U.S. Department of Energy
Office of River Protection

04-WTP-268

U.S. DEPARTMENT OF ENERGY (DOE), OFFICE OF RIVER PROTECTION (ORP)
RESPONSES TO THE DEFENSE NUCLEAR FACILITIES SAFETY BOARD (DNFSB)
CONCERNS

Responses to Issues Raised in July 21, 2004 Defense Nuclear Facilities Safety Board (DNFSB) Letter Regarding Waste Treatment and Immobilization Plant (WTP) Ventilation Systems Design

RPP-WTP HLW Vitrification Facility ISRS

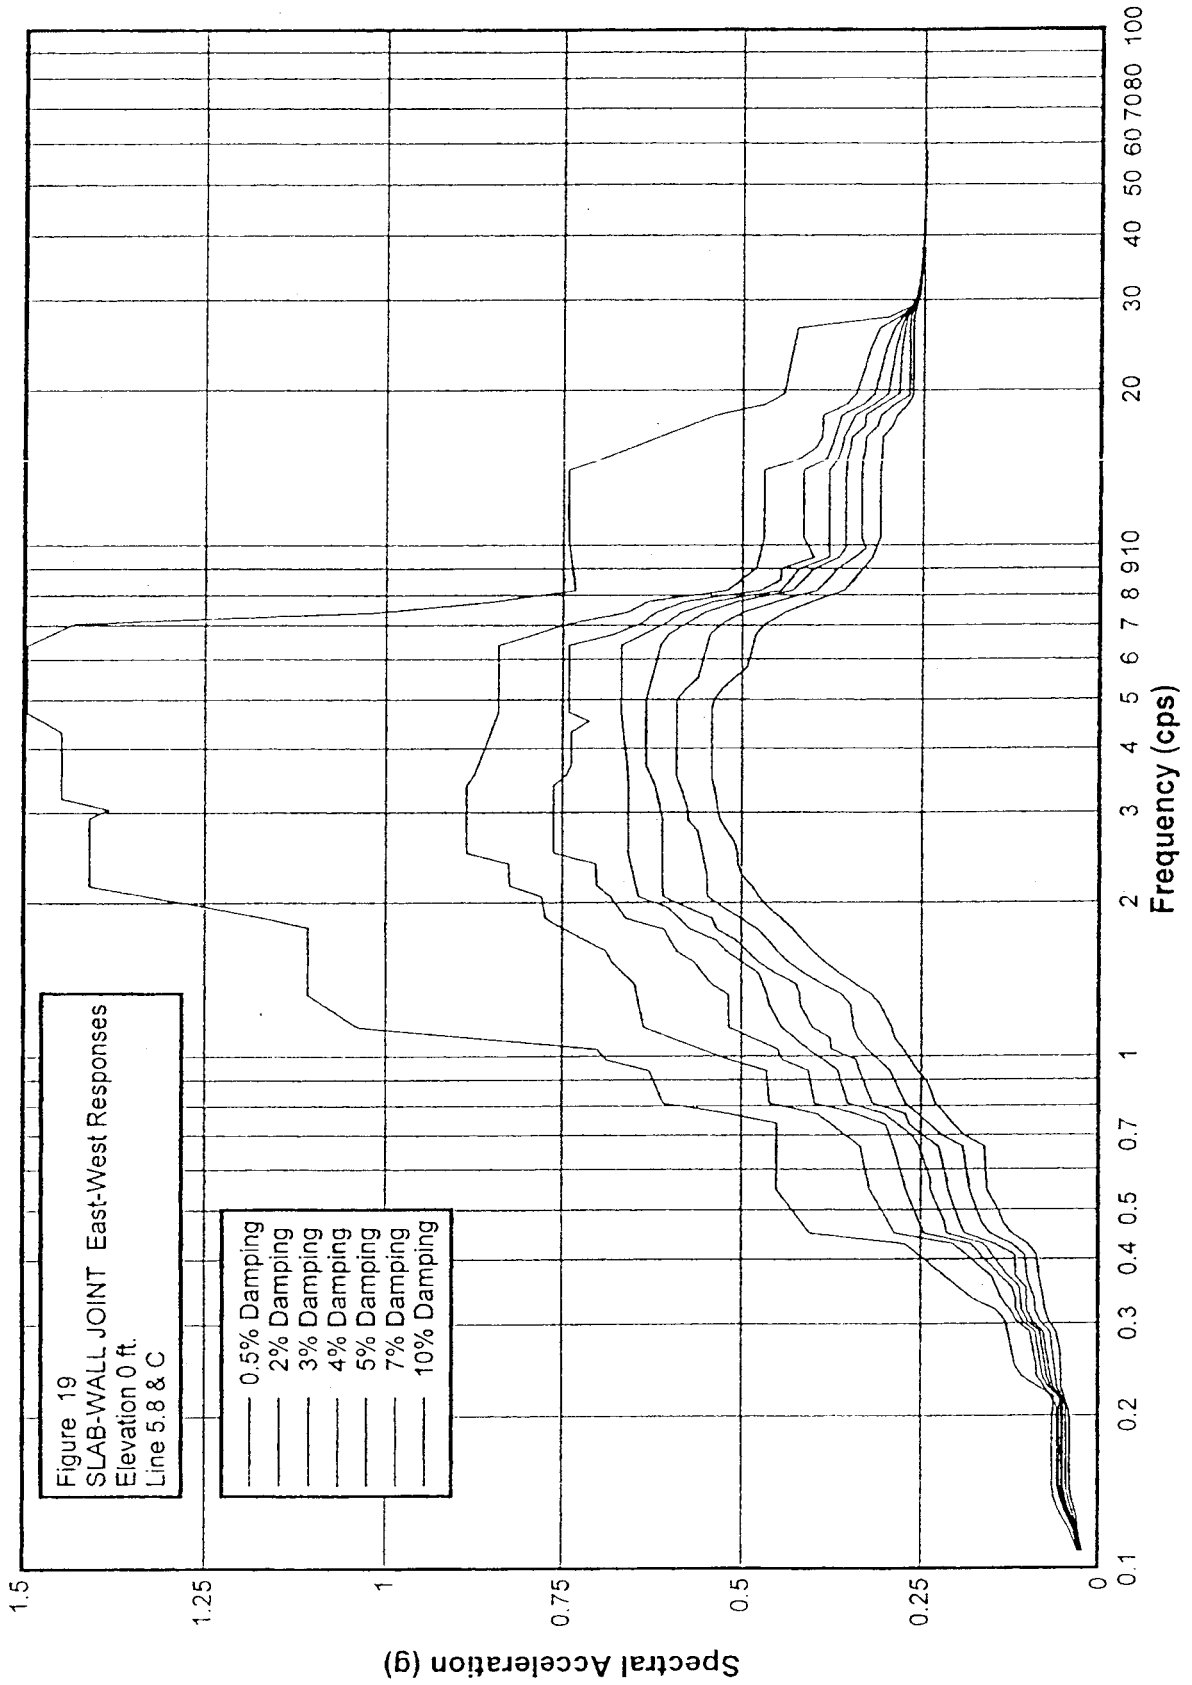
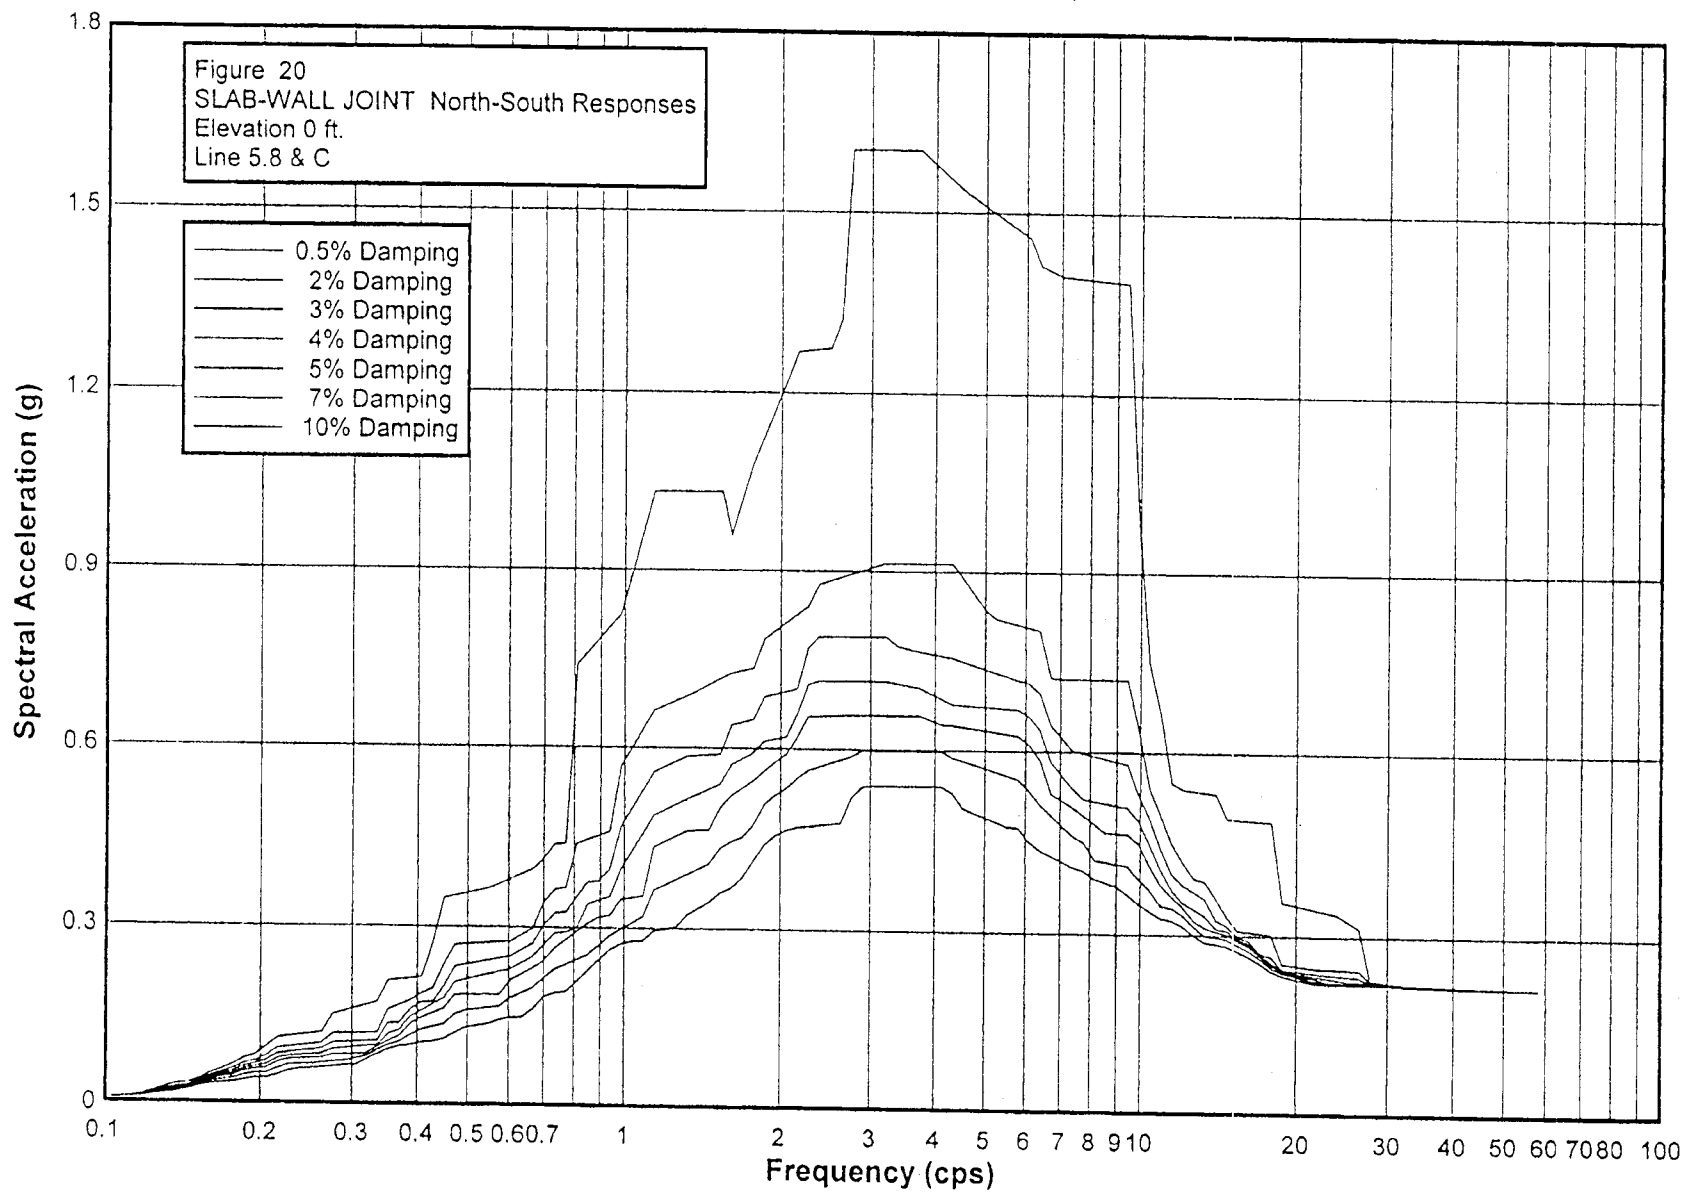
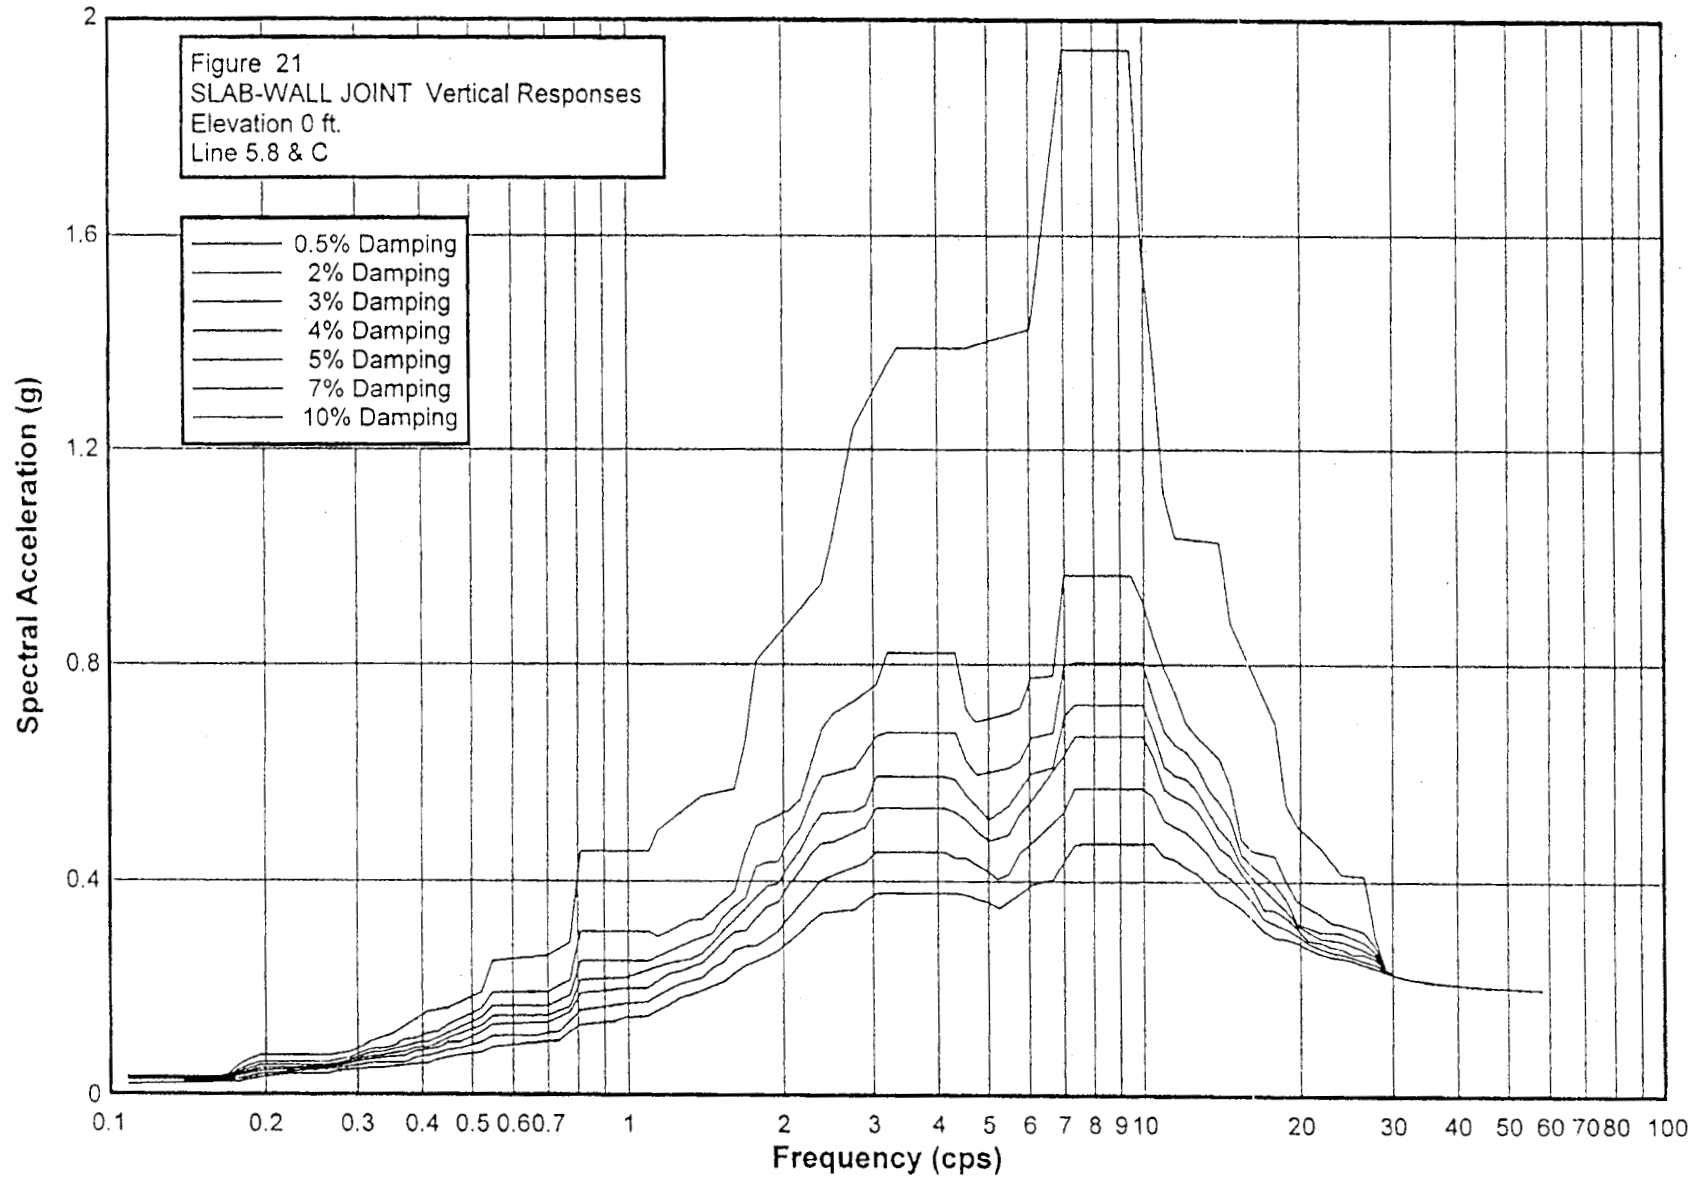
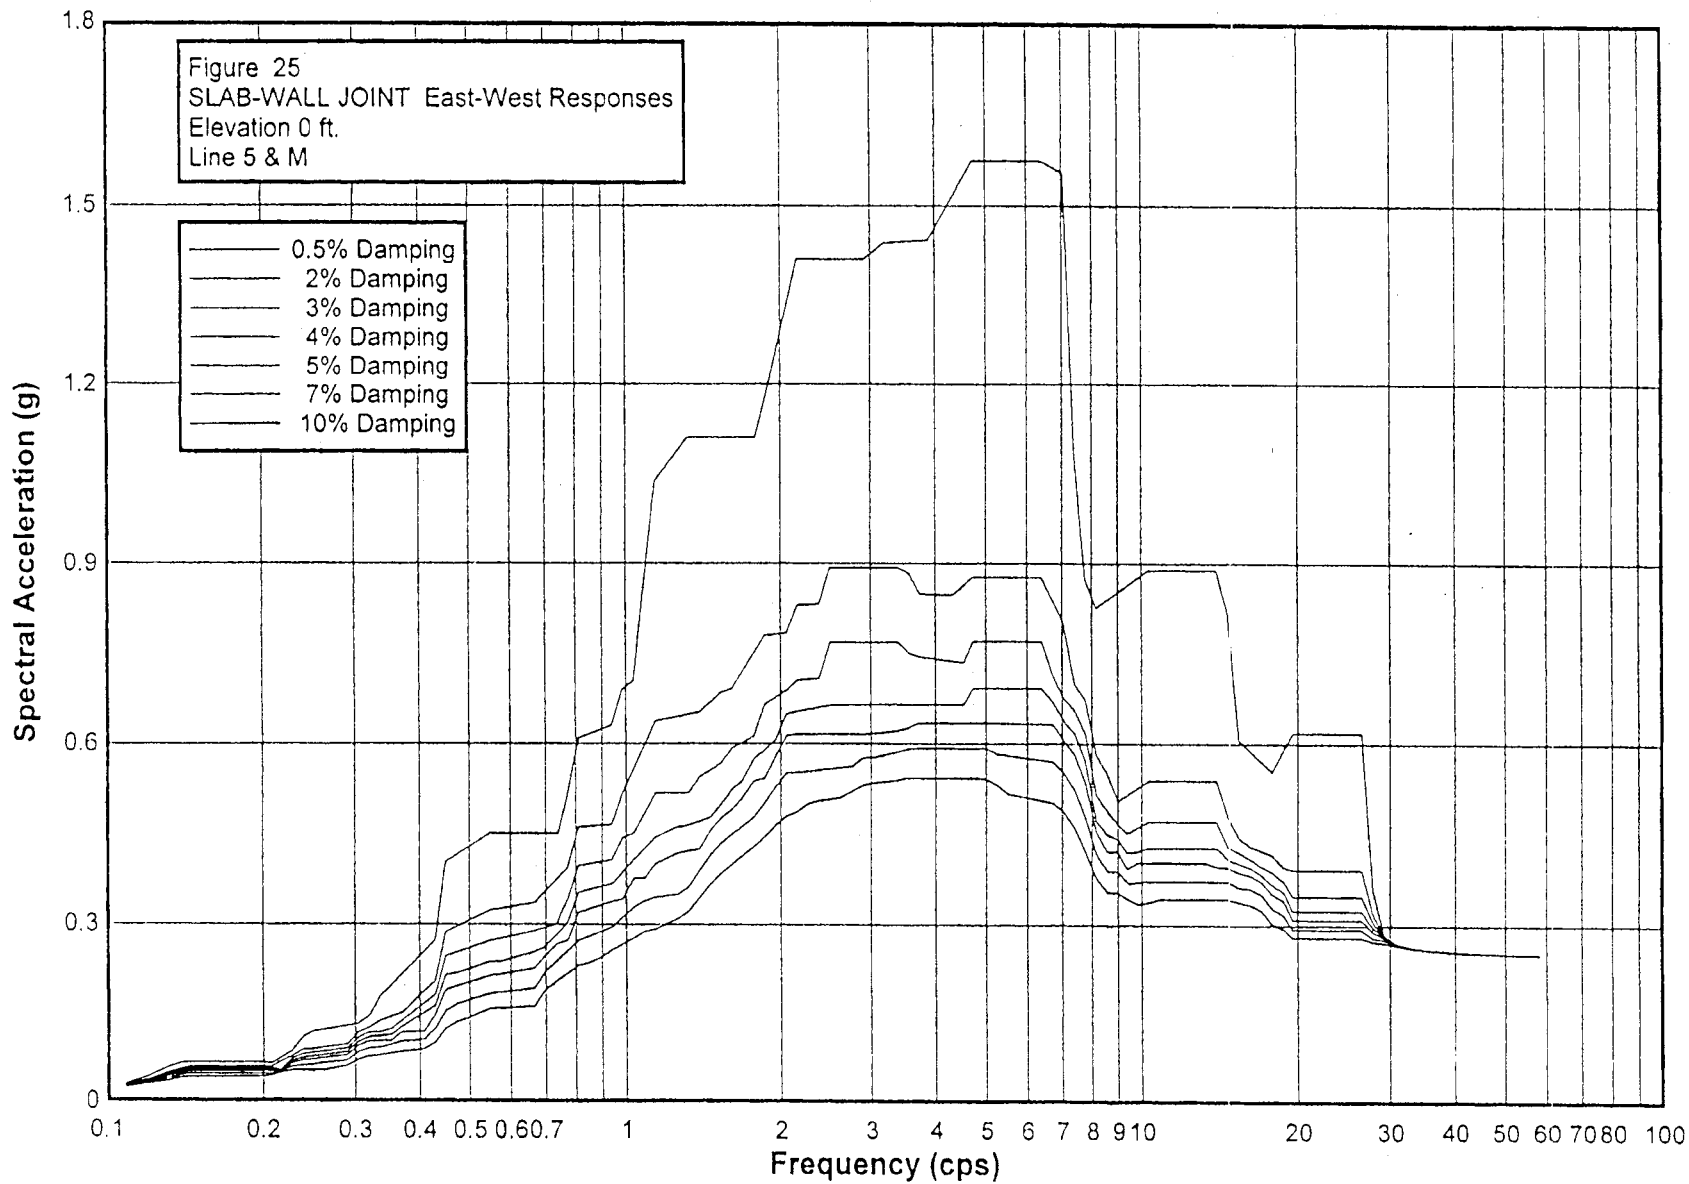
WTP-04-281-02 The planned ventilation filter housing shaker table tests will use a bounding seismic spectra as input for the shaker table tests. The staff wants to review the bounding data for suitability.

Response: The WTP Project will not use bounding data for the PT and HLW facilities. The specific In-Structure Response Spectra (ISRS) curves for each facility will be used and separate testing for each facility will be conducted. The applicable curves, by elevation and column line, for the Remote Change HEPA Filter housings will be used which shows the expected frequencies and accelerations in the north/south, east/west, and vertical directions. The reason for applying the ISRS curves specific to each building and not using bounding data is as follows:

The Remote Change HEPA Filter Housings in the PT and HLW buildings will require separate testing for the following reasons:

- a) The housings are supported by steel platforms. Since the platforms are not rigid, they need to be simulated for testing. The platform configurations are different. Therefore, their simulations would be different, requiring separate testing.
- b) ISRS for PT and HLW buildings are different.
- c) It is likely that the external loads on the housings, e.g., connected ducts, in PT could be different from those in HLW.

Enclosed are the ISRS curves applicable to the Remote Change HEPA Filter housings in the HLW and PTF facilities.†
